APPENDIX 3-C REVISED

Magnetometer Survey 2022

Subject: RE: Somerset Magnetometer Survey

Somerset Magnetometer Survey

Appendix 3-C Figure 3

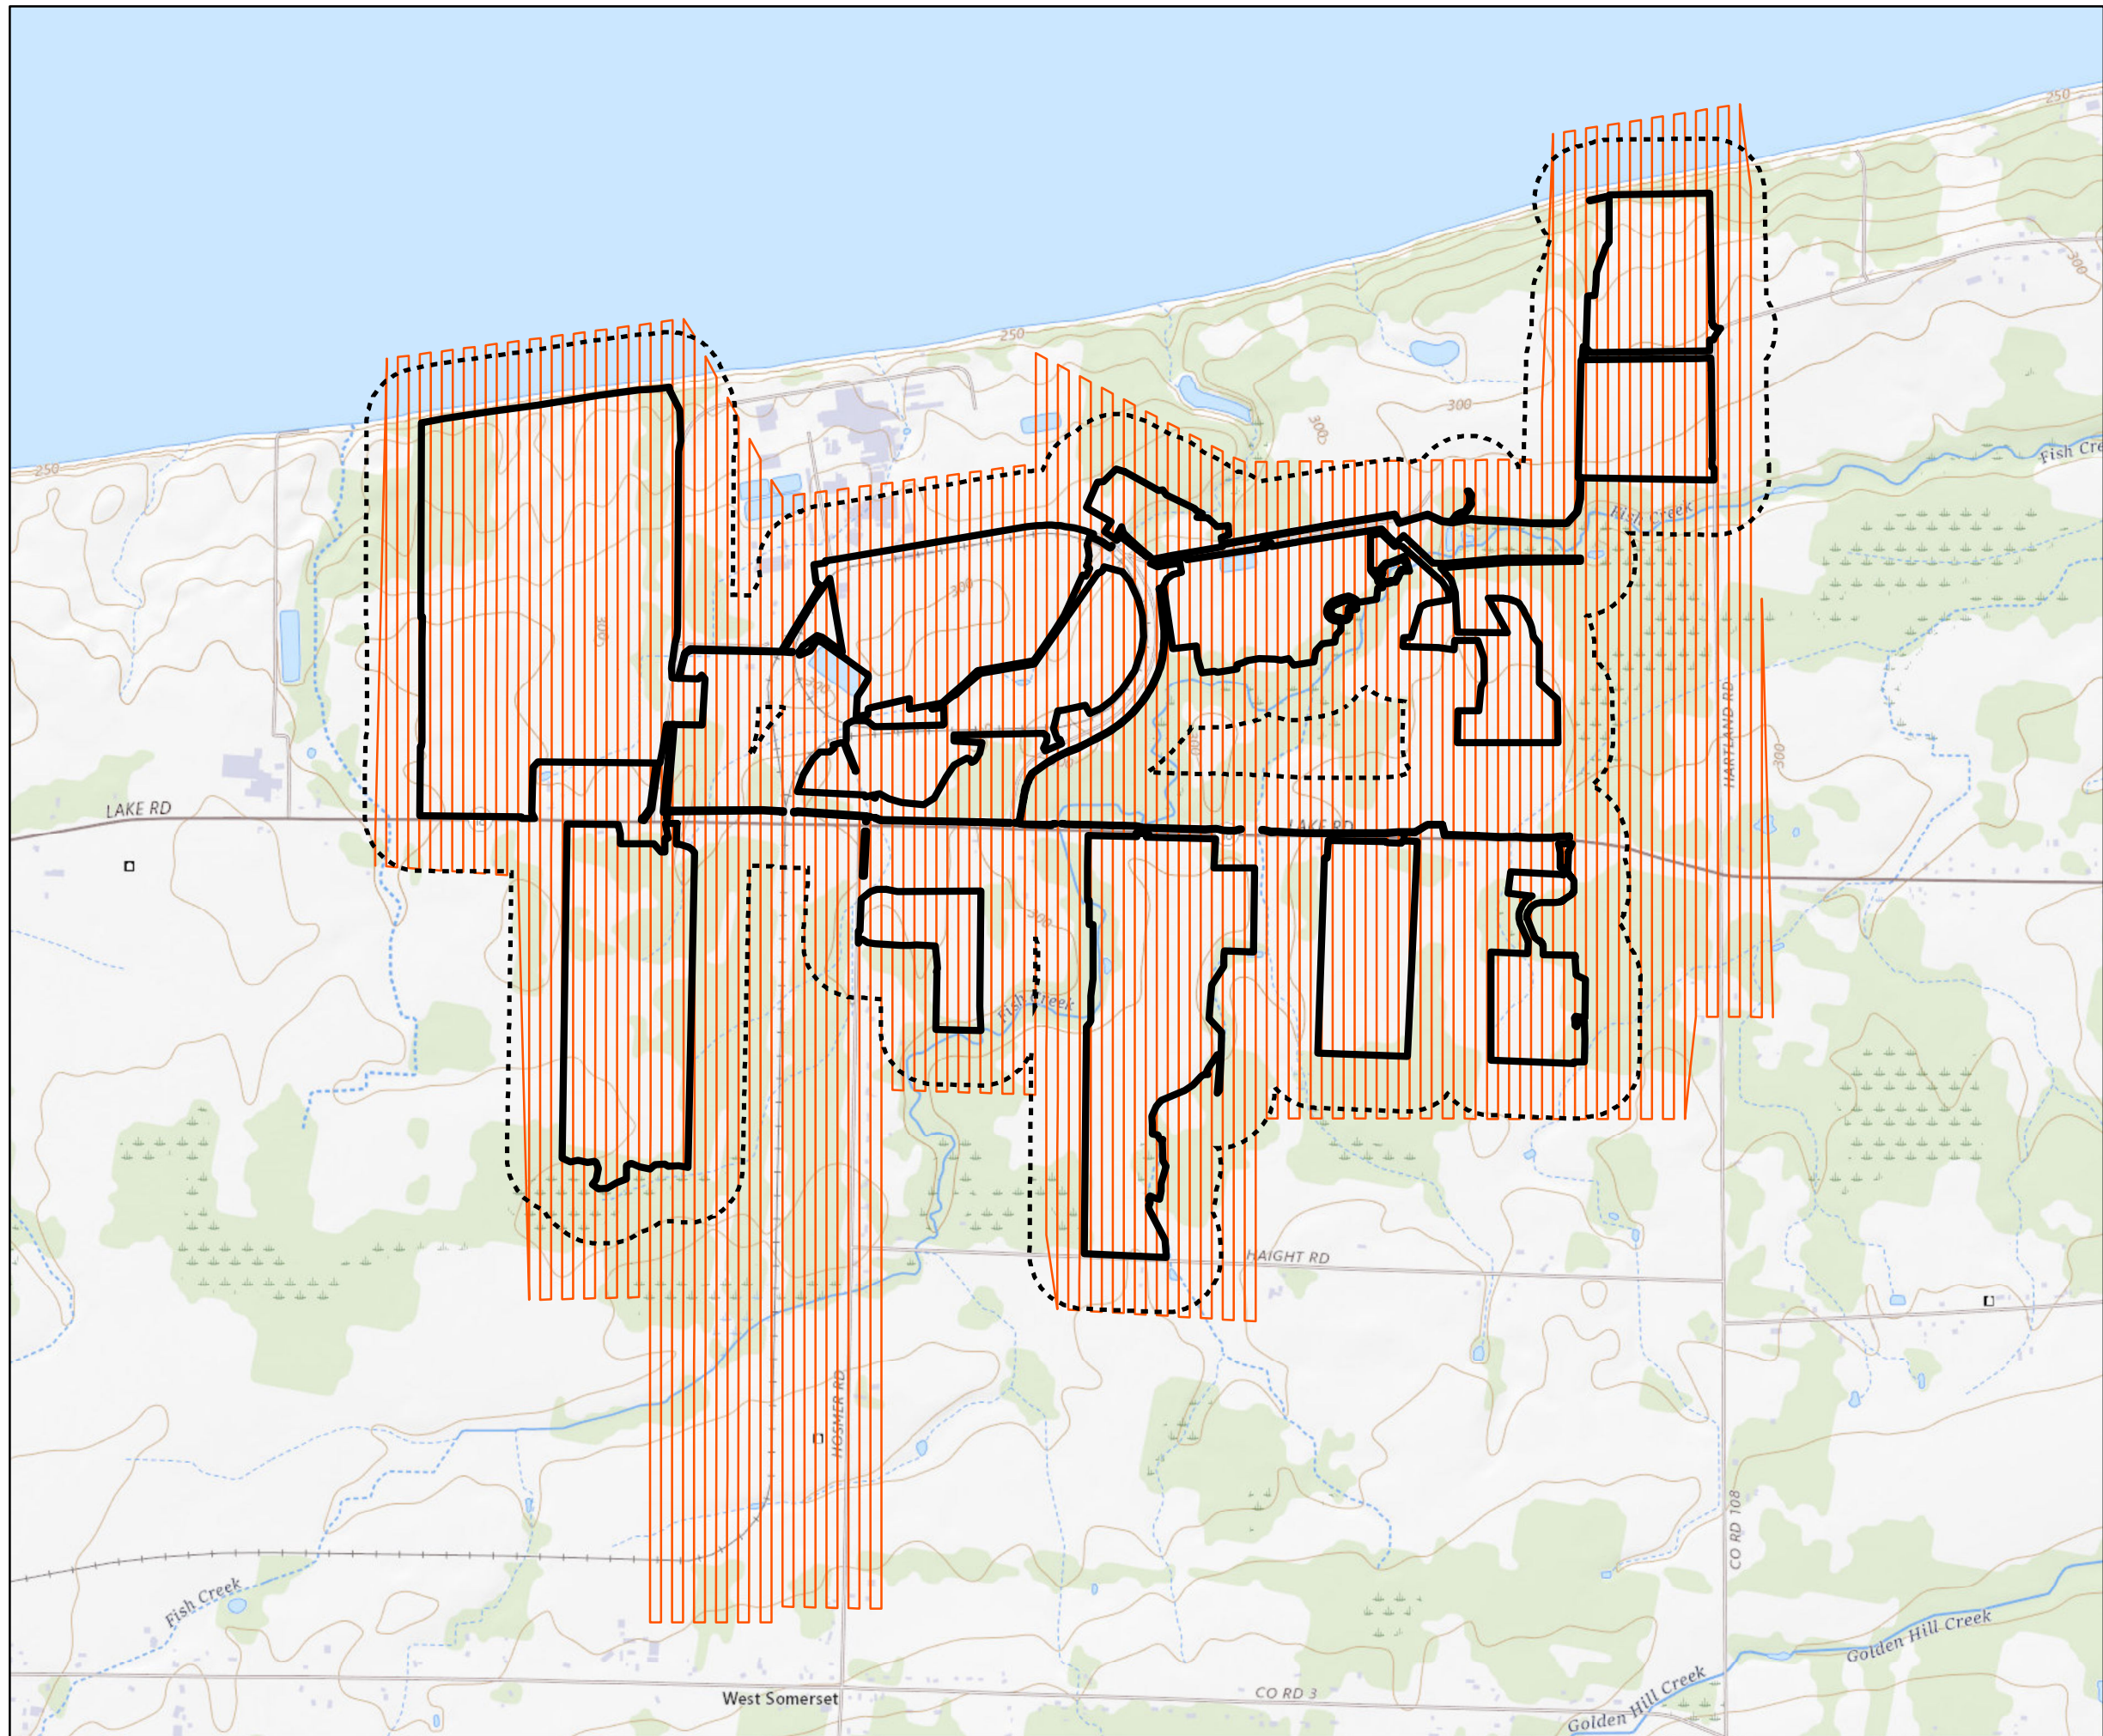
Hope you had a nice holiday. I'd like to push on this a little bit because we met with ORES today and they did in fact say the magnetometer survey did not meet requirements under 94c, so we really need the flight lines as well.

Thanks for sending this Google Earth .kmz over. What we also will need to address the specific questions from ORES are shapefiles of the survey flight lines as depicted in the below screenshot. Could you please send the shapefiles of the flight lines? Thank you!

It seems like Peggy has had some trouble reaching you the last couple weeks. We absolutely need shapefiles of the limits flown for the magnetometer studies to verify that we met ORES requirements. Both ORES and our team has suspicions that we have a data gap that we need to address. Our response is constrained by regulatory timelines and this data is crucial to finishing our response to comments.

Sorry for the delay on this. The project was archived and it takes longer to get all of the files restored. I can verify for you the areas below were flown. Each of these areas included an additional 500ft buffer.

Flight Lines Update with LOD and 500-foot Buffer

Figure 6 - Field Check Results

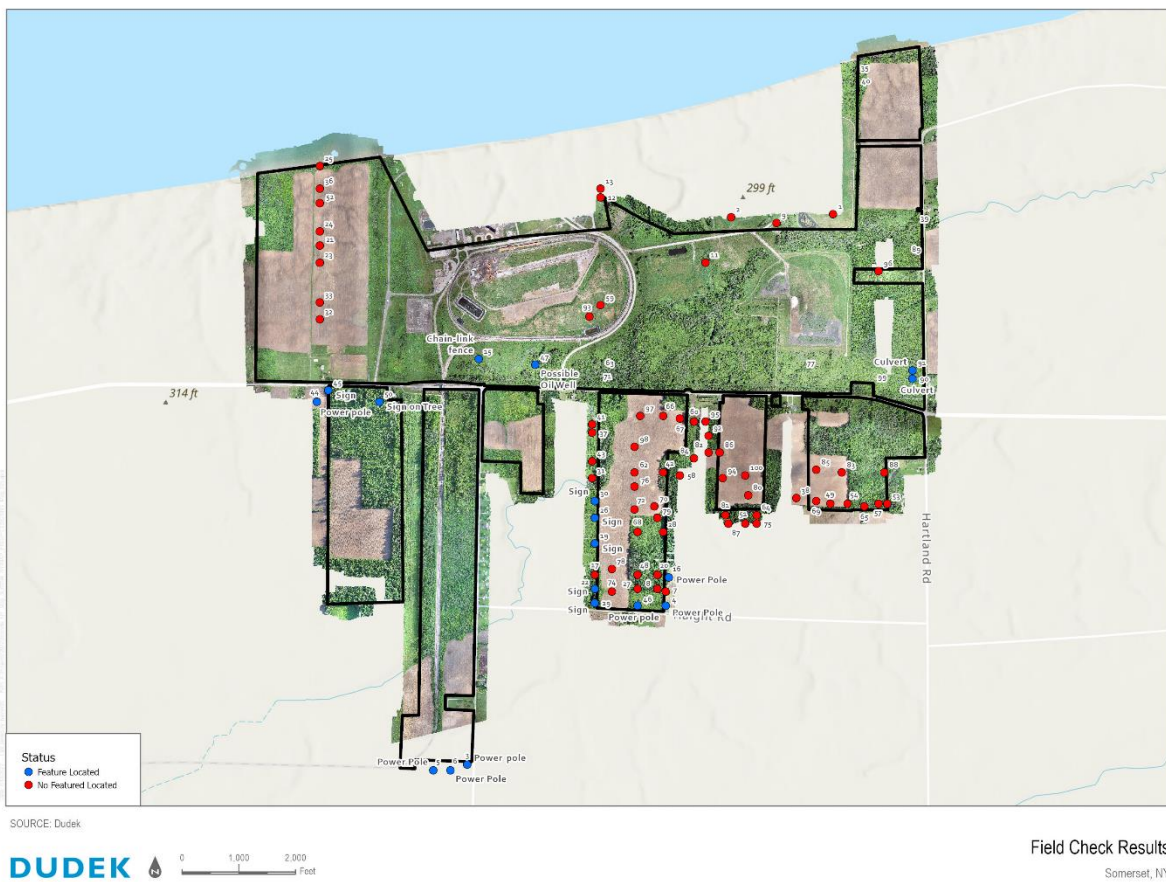
Comment	Appendix 3-C: Magnetometer Survey, states that 66 anomalies had no surface expression and were not investigated further. Please provide a complete record of the initial investigation of these anomalies or provide analysis by a qualified expert with supporting information explaining why the un-surveyed anomalies do not represent NYSDEC regulated wells.
Response

Comment	Appendix 3-C: Magnetometer Survey, states that 66 anomalies had no surface expression and were not investigated further. Please provide a complete record of the initial investigation of these anomalies or provide analysis by a qualified expert with supporting information explaining why the un-surveyed anomalies do not represent NYSDEC regulated wells.
Response

Our scope of work did not include time to investigate all anomalies on the project site. When we scoped the original project we discussed this item and the guidance we received was to complete the following.

Our team placed known anomalies on the project site prior to data collection. The known anomalies were used to verify the magnetometer was operating properly. After data collection was completed for the project site our field team checked the larger anomalies and they were all identified as trash items on the project site. Based on the field verification work that was completed the geophysicist that we worked with us on the project reviewed the data that was collected and determine that the anomalies on the site were not representative of oil infrastructure.
